Subject: Independent Design Review for the Shoreham Nuclear Power  
Station

Please find enclosed the latest classification of items from the subject  
design review.

INDEPENDENT DESIGN REVIEW

SHOREHAM NUCLEAR POWER STATION

EAP 5.4, REV. 3  
PAGE 17  
ATTACHMENT 6.5

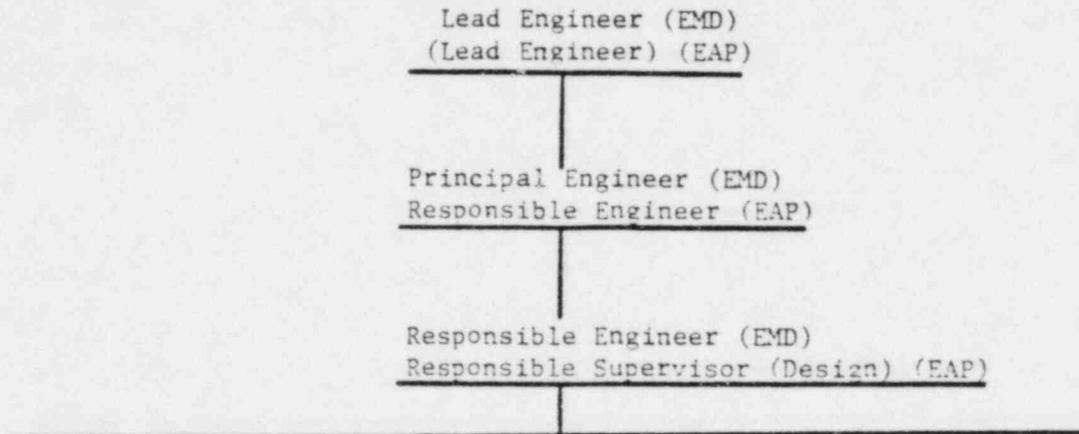
In a meeting at SWEC in Boston on February 15, 1983, the Shoreham pipe support design process was discussed - in particular, the requirements of SWEC EAP 5.4, Page 17 (Attachment 1), shows a sample title block with the corresponding required signatures. The titles (DS, DC, RE, LE, PE) are defined for the EMD organization in the attached chart (Attachment 2). Thus, it is noted that those responsible for the calculations must sign the drawing. The calculations may not be updated to reflect the latest issue of a drawing.

This signature requirement provides documentation that the necessary review and interfaces exist in this portion of the Design Process. ICR-5633-17 should be Closed based on the above.
